Stable Lane Car Park

Stage 1 Road Safety Audit

Malachy Walsh & Partners

November 2023

Figure 2.3 – Conflict between Incoming Vehicle & Reversing Vehicle

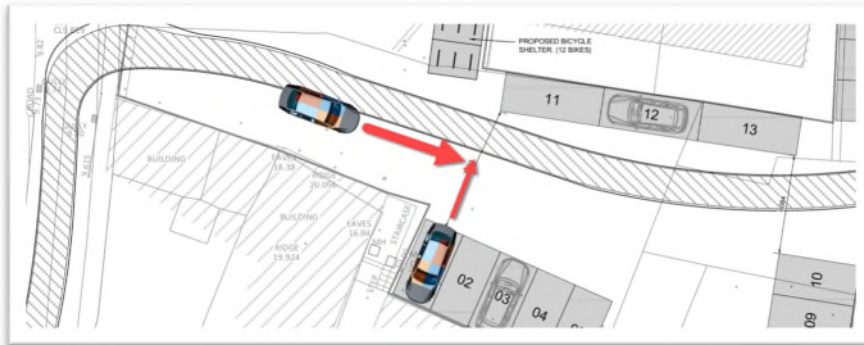
2.3 Problem: Vehicles Reversing into Path of Inbound Traffic

Location: Vehicle Entry Point & Car Park Spaces 1 - 5

Vehicles reversing out of car parking spaces 1 to 5 are unlikely to be able to register a vehicle entering from their right. This could lead to sudden braking and side impact type collisions.

The risk should be mitigated by narrowing the inbound circulatory lane (to slow entry speeds) and by moving car parking spaces 1 to 5 north (to improve intervisibility).

Figure 2.4 – Sight Line at Car Park Exit to Northbound Vehicle on Stable Lane

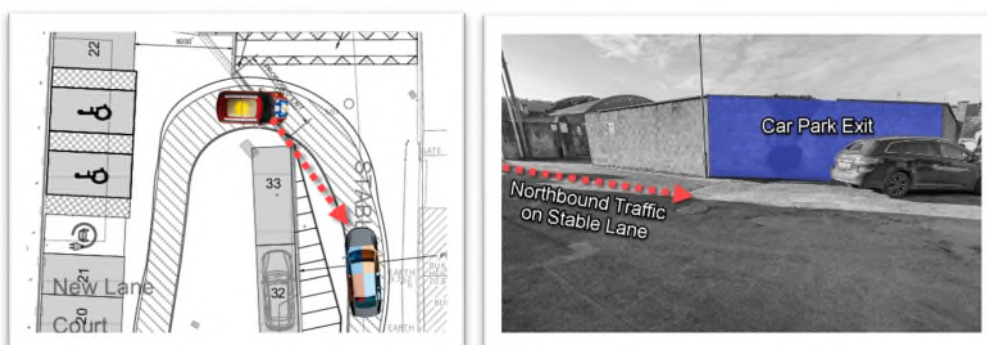
2.4 Problem: Sight Lines at Car Park Exit

Location: Car Park Exit onto Stable Lane

Drivers exiting the car park onto Stable Lane will have their line of sight to northbound vehicles on Stable Lane partially obscured by parking space 33 and (possibly) the adjacent boundary wall. This could increase the risk of a collision on Stable Lane at the car park exit.

To throttle northbound vehicle speeds on Stable Lane, the proposed speed ramp should be extended south to create a junction table across the full width of the car park exit. This should be coupled with constructing a buildout on Stable Lane (adjacent to spaces 32 & 33) to create a buffer for vehicles exiting the car park to advance into and improve their sight line looking to the right.
